Ettade Jeans Limited

1670/2091, West Sholashahar, Building #3, Aturer Depot, Chittagong
(22.382352N, 91.827703E)
20 April 2014

Observations

High stress in columns

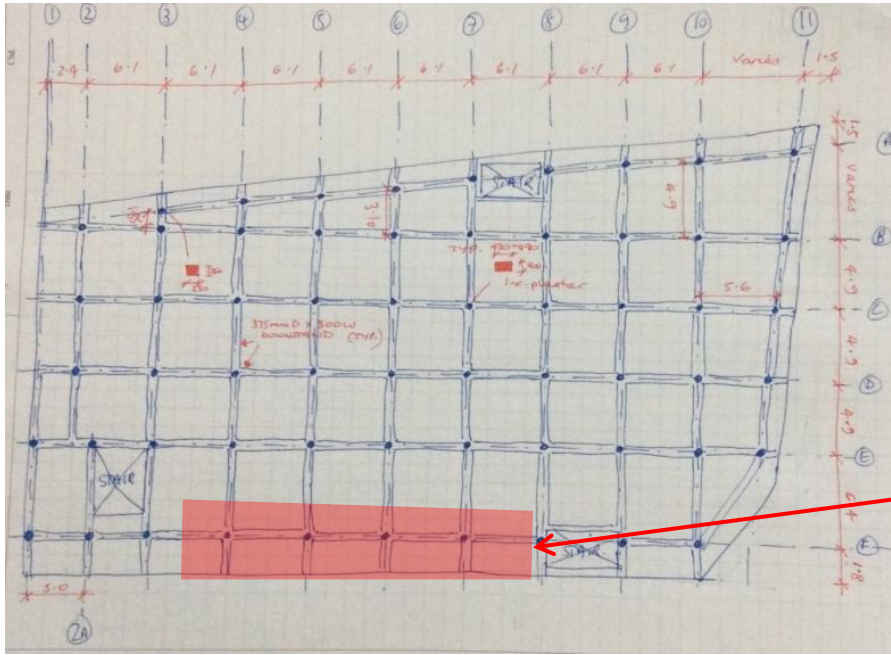
Columns support a cantilever of 1.8m carrying a brick façade.

Cursory calculations at ground floor level indicate that edge column's working stresses are at a high level.

Some columns extend below.

High stress in columns

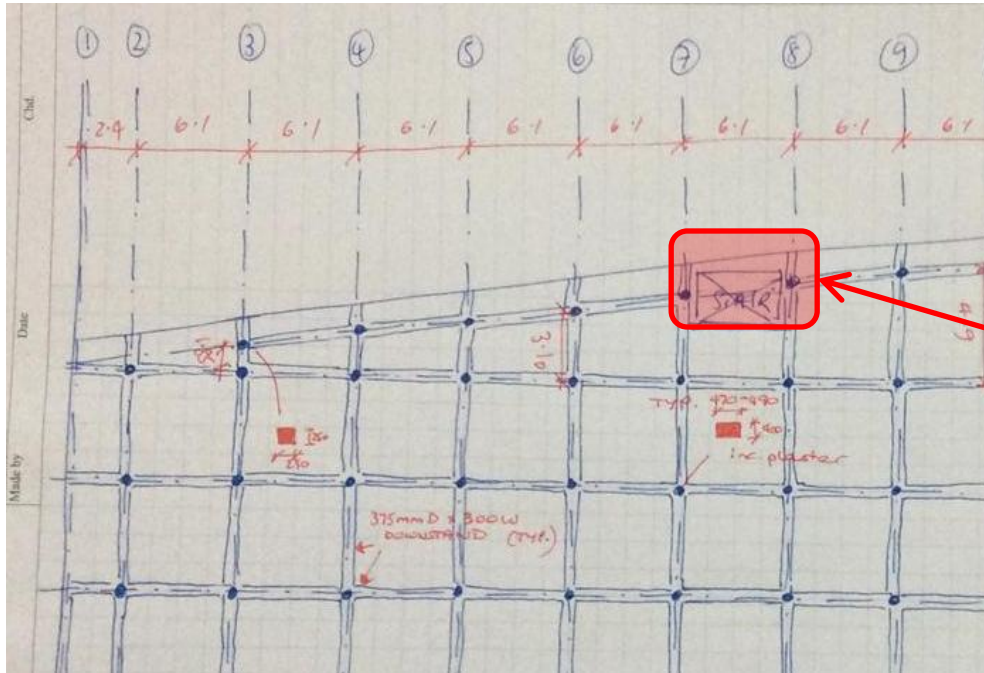
Part of ground floor slab is suspended over a pond.

The columns and retaining wall beneath the ground floor slab were inaccessible and could not be inspected.

The ground floor slab in this area is subjected to high floor loads from storage of rolled materials.

Cursory calculations under the ground floor warehouse show edge column stresses are very high.

It was not possible to get close to the columns, however some vertical cracking may be apparent.

The warehouse storage should be removed and the pond should be drained immediately so that the columns and wall can be checked for signs of distress.

A qualified engineer should confirm that the ground floor columns, slabs and beams have sufficient capacity to support the loads including high storage loading at ground floor.

Water tanks on roof

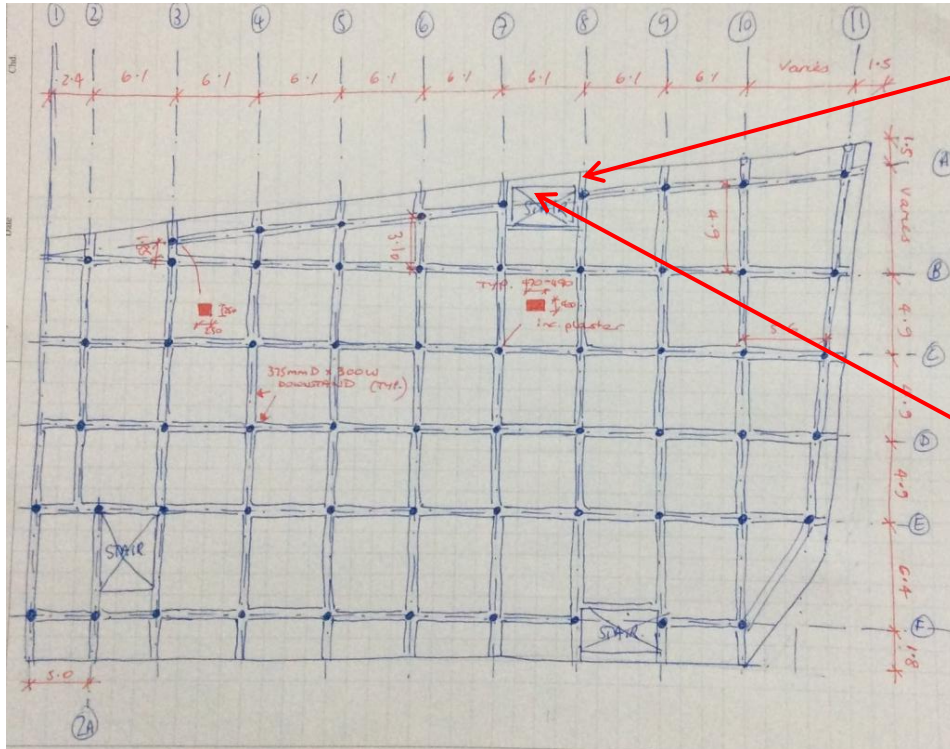
Water tanks with a total capacity of 18000l are located on the roof above the stair core.

The stair lid slab spans between masonry walls which load the cantilevering roof slab below. There are signs of distress in the cantilevering beams at fifth floor level

It was unclear if the water tanks were supported on a plinth of any kind.

Water tanks on roof

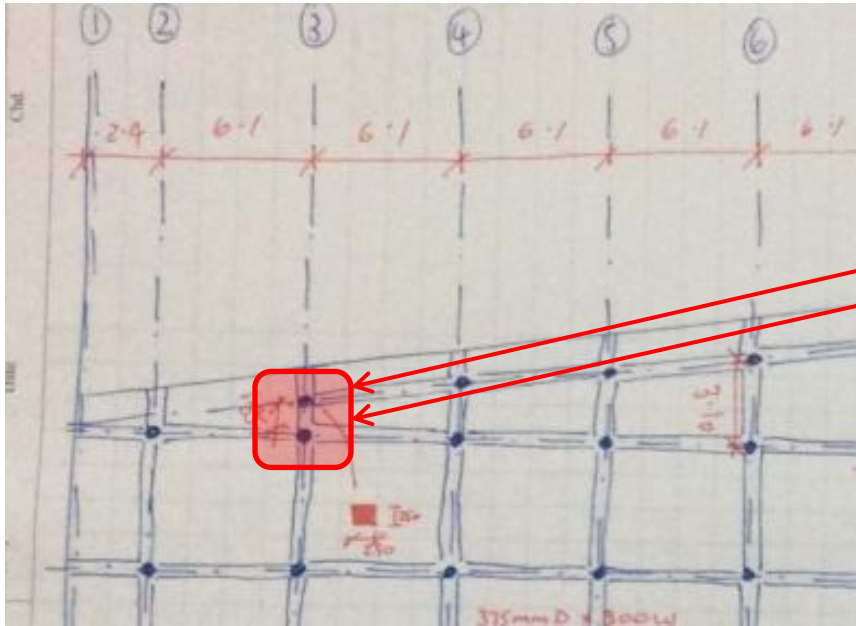
Vertical cracking to cantilevering beam observed at high level fifth floor

Horizontal and diagonal cracking observed in masonry wall directly below water tanks

Diagonal cracks in façade at ground floor

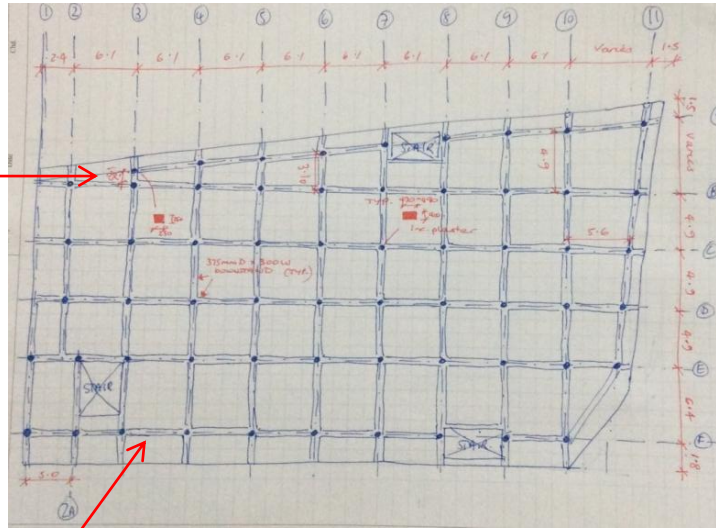
Small 250x250mm column (grid A3) located directly adjacent to typical edge column (grid B3).

Cursory calculations indicate that the stress in the small column is very high, however the adjacent column is capable of carrying the full load for both tributary areas.

Diagonal cracking was observed in the façade at ground floor in the locations noted, this may be a sign of foundation settlement.

A trial pit should be dug to confirm the foundation type and an engineering assessment should be carried out to confirm that the foundation type is suitable for the ground conditions.

The façade cracks should be monitored for further movement by installing tell-tails. Once movements have stopped cracks should be repaired to prevent on-going maintenance issues.

Horizontal cracking in masonry wall

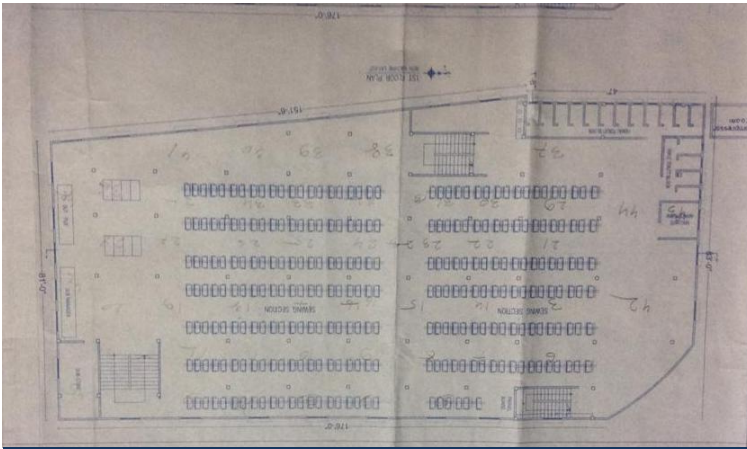
Horizontal cracks observed in masonry walls where cantilever floor beam has deflected and is now supported by masonry.

Masonry wall is now providing support to first floor slab. No structural modifications to be made to wall (e.g. openings being created for doors or windows)

Factory layout drawing

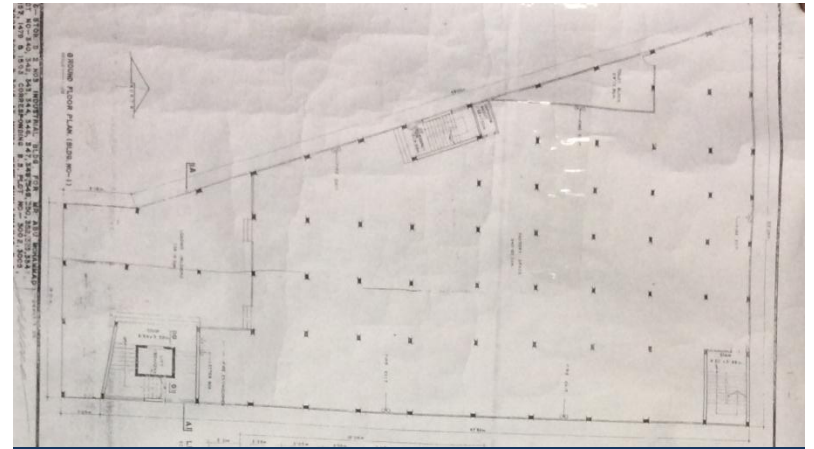
No drawings for the RC superstructure or substructure was available, the foundation system is unknown. The factory layout and building permit drawings do not match the as-built frame.

Engineer to develop accurate drawings showing the as-built structure.
